APEX MAIN EMS STATION

6950 APEX BARBECUE ROAD, APEX, NORTH CAROLINA 27502 | WAKE COUNTY REQUEST FOR BIDS NUMBER: RFB-23-080

ADDENDUM NO. 2

DATE: OCTOBER 19, 2023

SHEET: E501

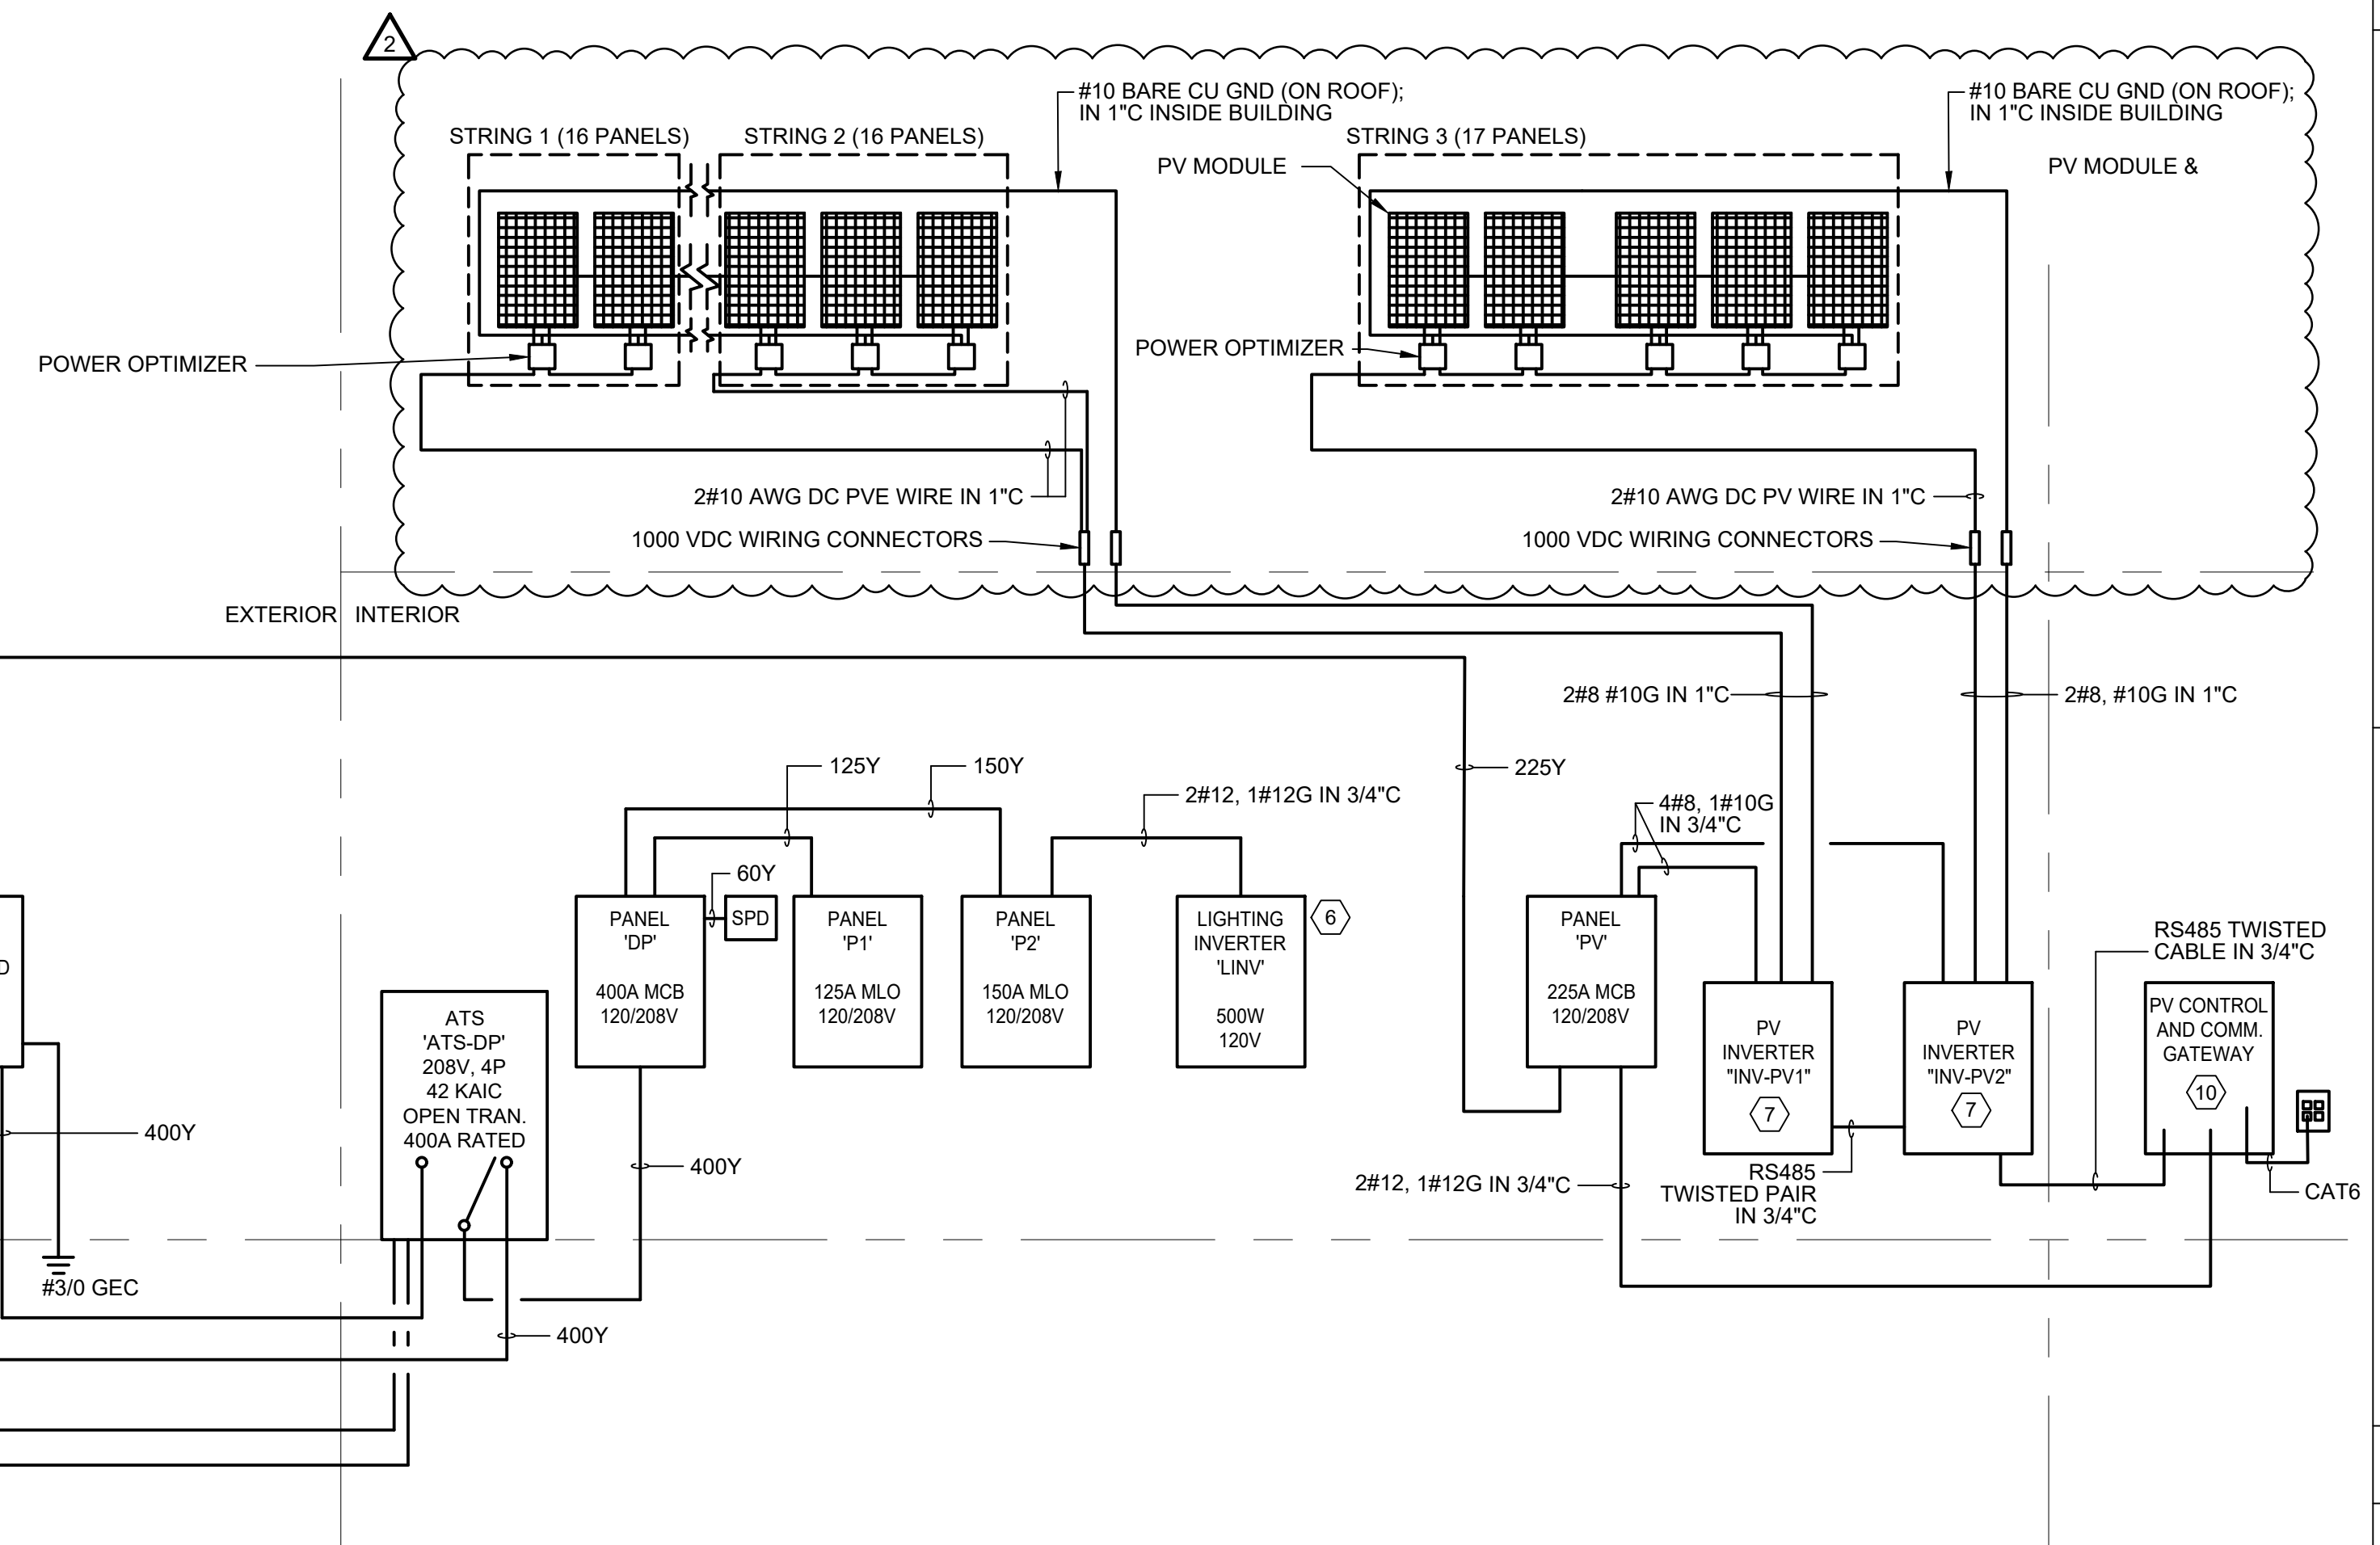
1. **REPLACE** Sheet E501 – Electrical Power Riser with the attached, updated E501 – Electrical Power Riser (Revision 2, Dated 10/19/23). Solar Photovoltaic (PV) Base Bid and Alternate Descriptions previously added in Addendum No. 1 added to drawing. Electric Vehicle (EV) Base Bid and Alternate Descriptions previously added in Addendum No. 1 added to drawing.
